RE: Committee Meeting #1 – Kick-off

**DATE:** June 13, 2003  
**RE:** Committee Meeting #2 – Analysis and Planning Concepts

**RE:** Committee Meeting #4 – Preferred Plan

*Figure A.14: September 4, Preferred Alternative*

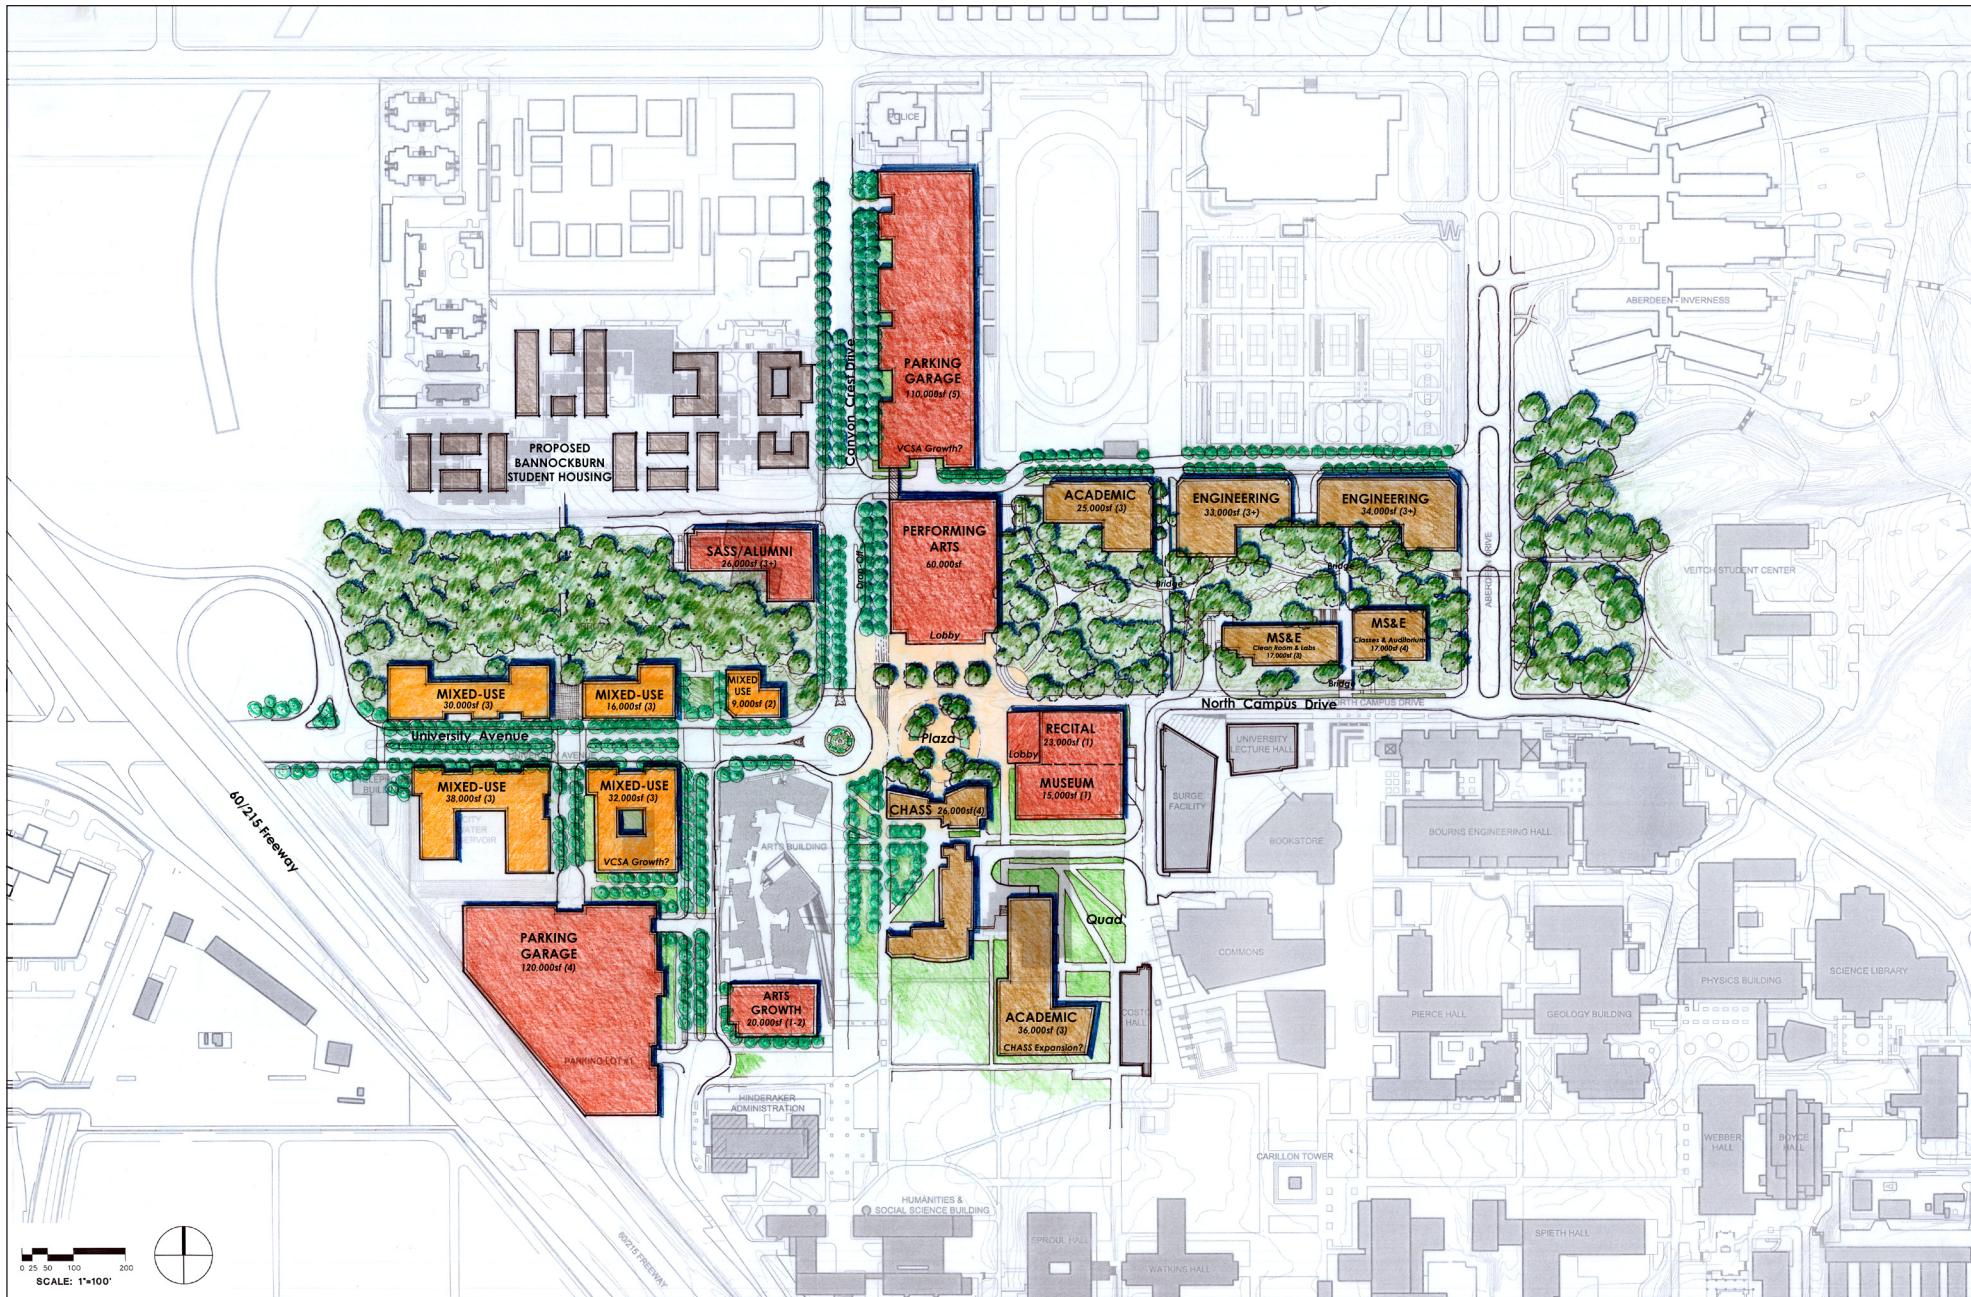
1.7 Andy Plumley asked for clarification on parking to meet the needs of restaurants and shops to be located within the mixed use area north of University. Doug Macy stated that the plan relies on the student resident population for support, with additional visitors accommodated in the nearby University parking structure. Additional spaces are also incorporated within the mixed use development south of University. He also noted that additional strategies could be implemented, such as basement level parking at the mixed use development and/or on-street parking, to further accommodate parking needs. Doug proposed the strategy of putting out a request for development teams to study this element of the project and inform the University of what implementation strategies would make the most functional and economical sense. Nita requested that the team document these suggested strategies within the report.

- 2.1.2 The presentation included “north” (*Figure A.15*) and “south” (*Figure A.14*) siting alternatives for the forthcoming Materials Science and Engineering Building to study access issues. The board indicated a preference for the south alternative for the following reasons: the service access could be sufficiently screened through further design studies, and this location offers stronger programmatic adjacencies with core campus Engineering and CNAS facilities (and avoiding “leapfrog” development patterns in the study area). The board cited the following shortcomings of the north alternative: requirement for a significant retaining wall to accommodate a grade change at this location, and discontinuous service drive condition eliminating service vehicle, bicycle and pedestrian access along the northern edge of the site between Aberdeen Drive and Canyon Crest Drive.
